ON-SITE SEWAGE DISPOSAL SYSTEM
HOWARD COUNTY HEALTH DEPARTMENT
BUREAU OF ENVIRONMENTAL HEALTH

SUBDIVISION: Warfield Brothers LOT NUMBER: 3

ADDRESS: 14361 Howard Road PROPERTY OWNER: NVR Inc.

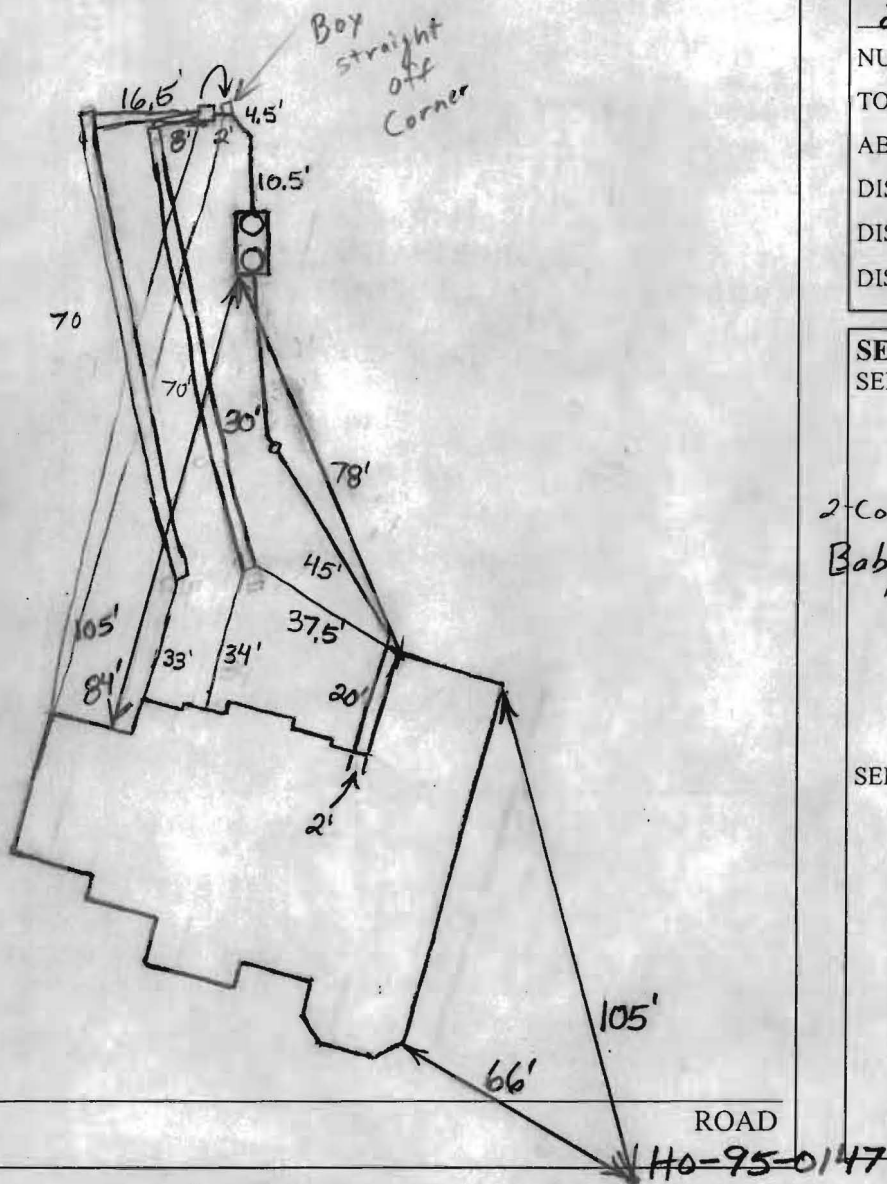
PRE-CONSTRUCTION 5/11/06 Homeowners want to install part of a circular driveway in the septic easement. Need plan showing proposed location before proceeding. May need further perc. testing and new perc. cert. Full on corner of easement closest to house. (BB) 5/16/06 Still don't have plan and builder not on site. Put on hold until plan received. (BB) 6/16/06 Received plan that showed driveway location. Tanks set 5+ on outside of driveway circle. (BB) 7/6/06 House connection made. (BB)
